## Response to Reviewer #2

### **Comment on Revised manuscript “TransClim (v1.0): A chemistry-climate response model for assessing the effect of mitigation strategies for road traffic on ozone”**

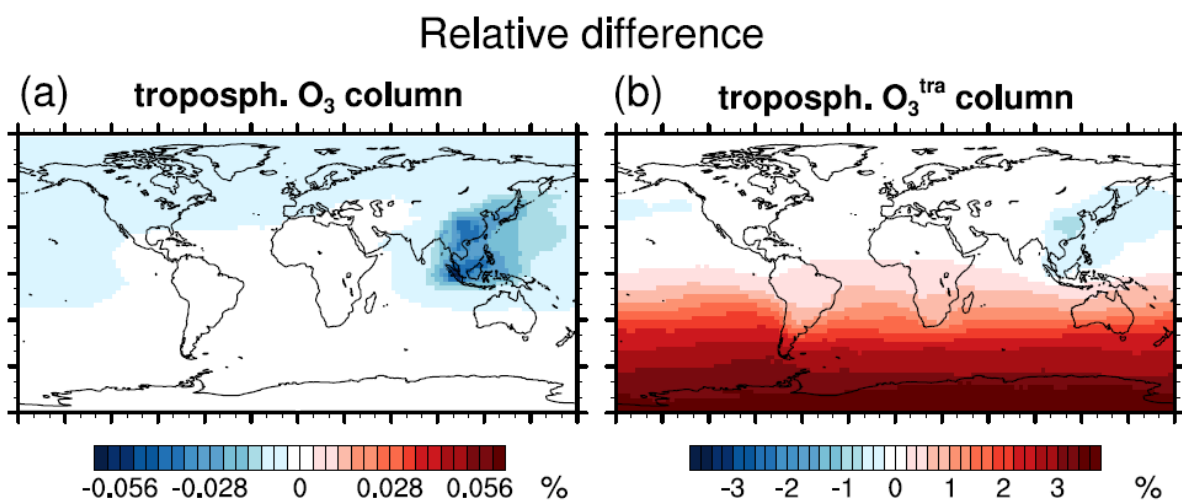
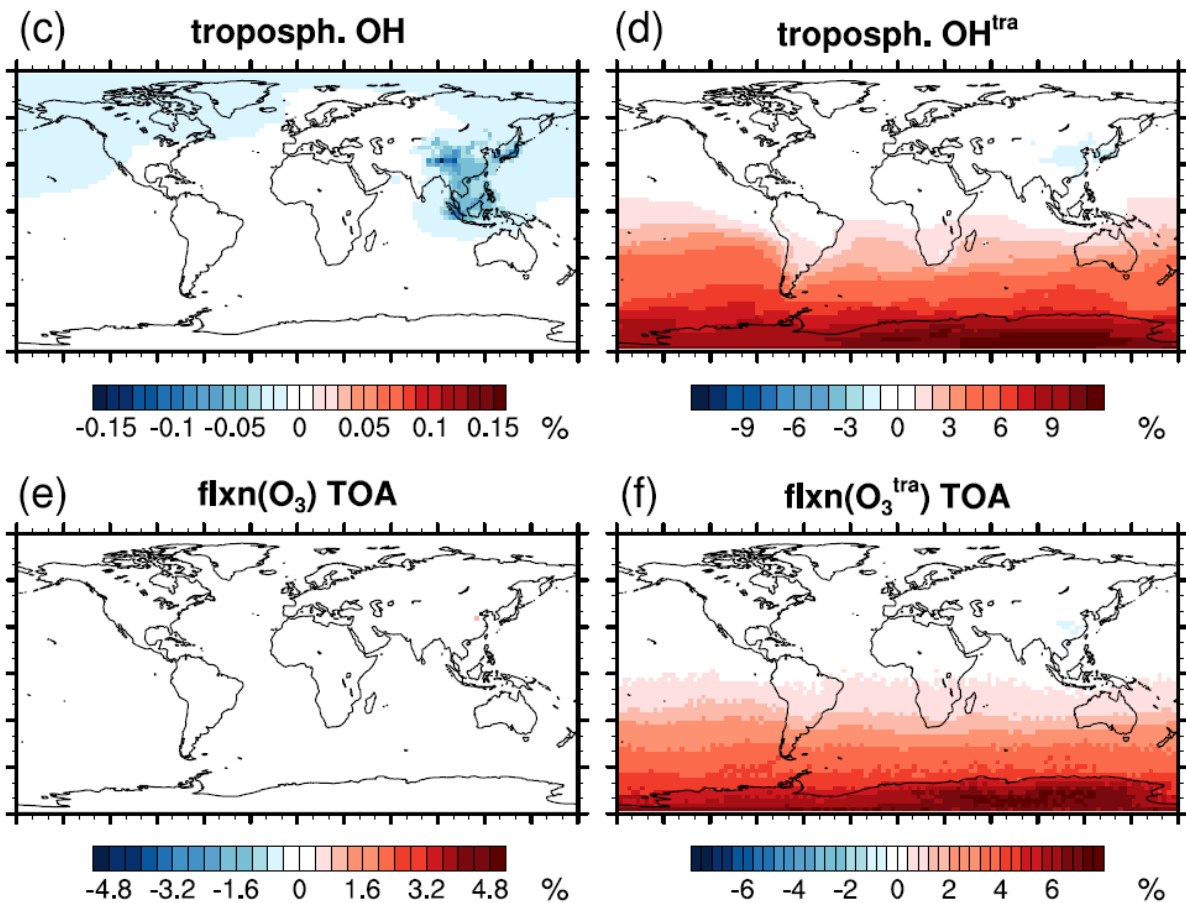
Line 332-330 – so similar problem as presented in Fig 5 but positive bias now?

*Exactly, in this case TransClim overestimates the contributions  $O_3^{tra}$ ,  $OH^{tra}$  and  $flxn(O_3^{tra})$  only in the Southern Hemisphere (see figure below). This is again caused by the small values in the Southern Hemisphere. To compute the relative differences, the absolute differences are divided by these small values which generate this noise.*

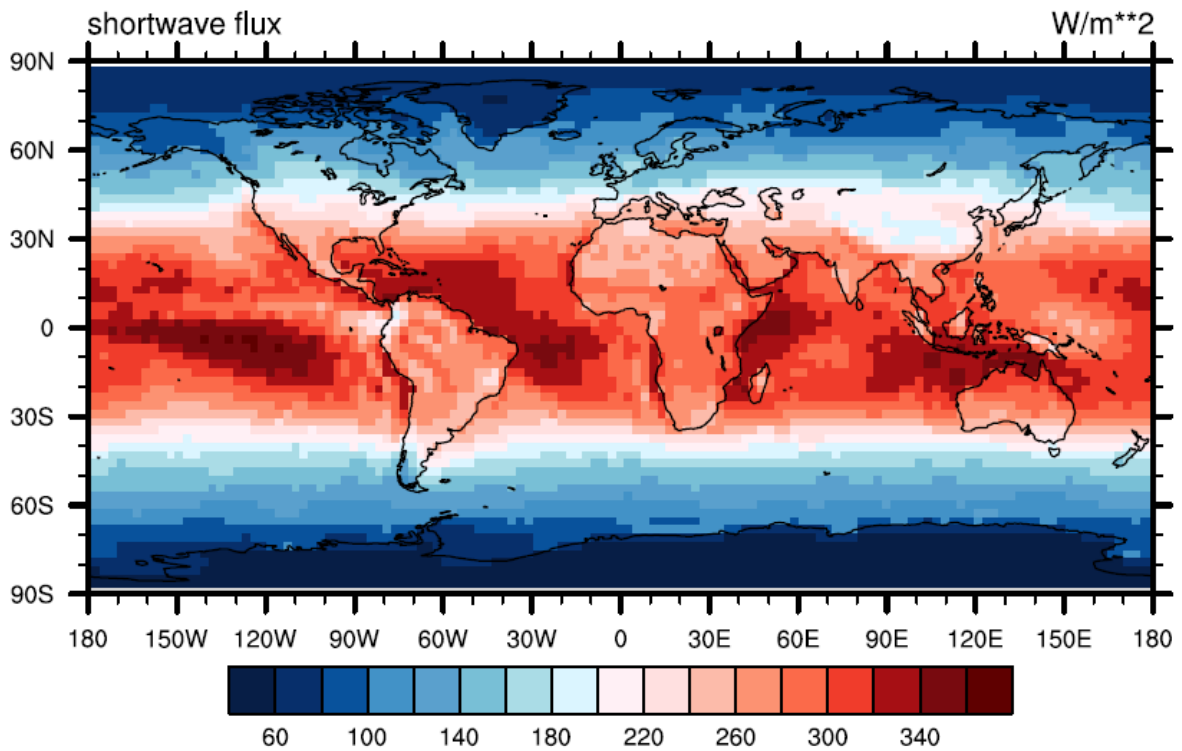
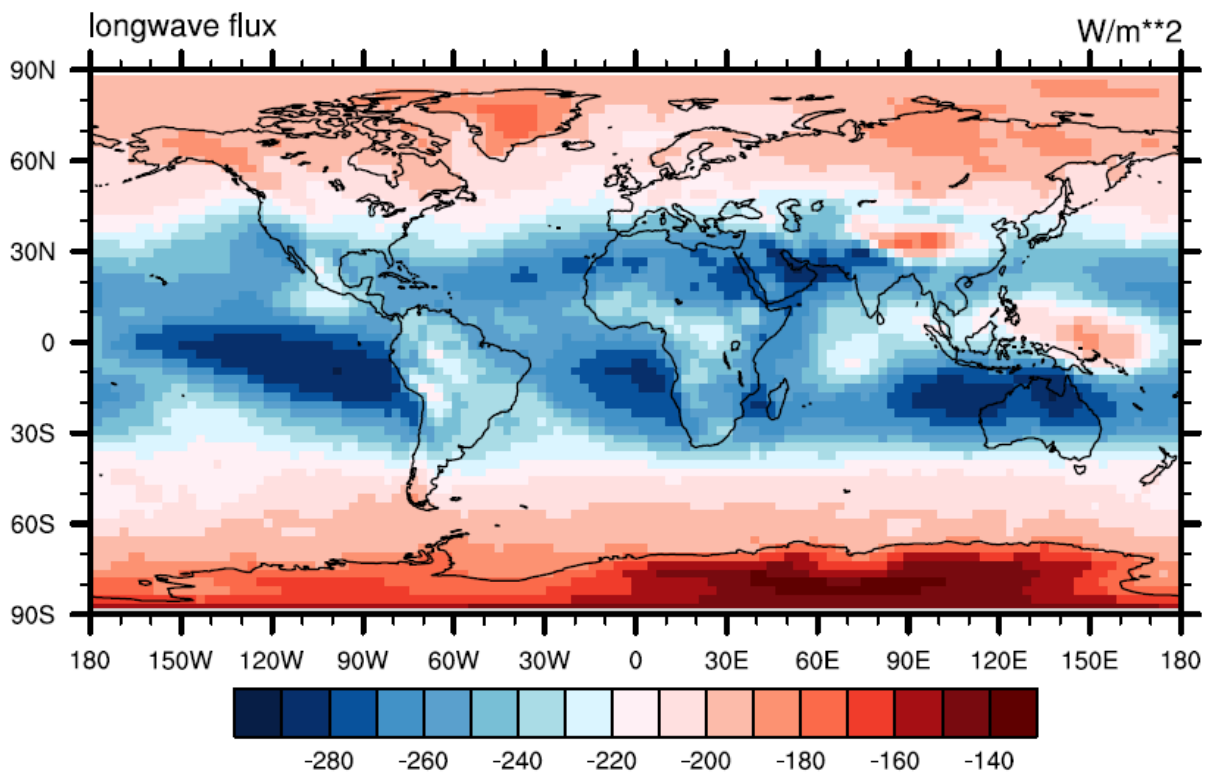
Fig A1 – It is correct that there are negative values for Flxn(O<sub>3</sub>) at TOA? Is this including stratospheric O<sub>3</sub> too?

*The plot shows the net radiative fluxes due to ozone at TOA. It includes the tropospheric and stratospheric ozone. The net radiative fluxes are computed by adding the shortwave and longwave radiative fluxes (shown below) resulting into positive and negative radiative fluxes for ozone.*
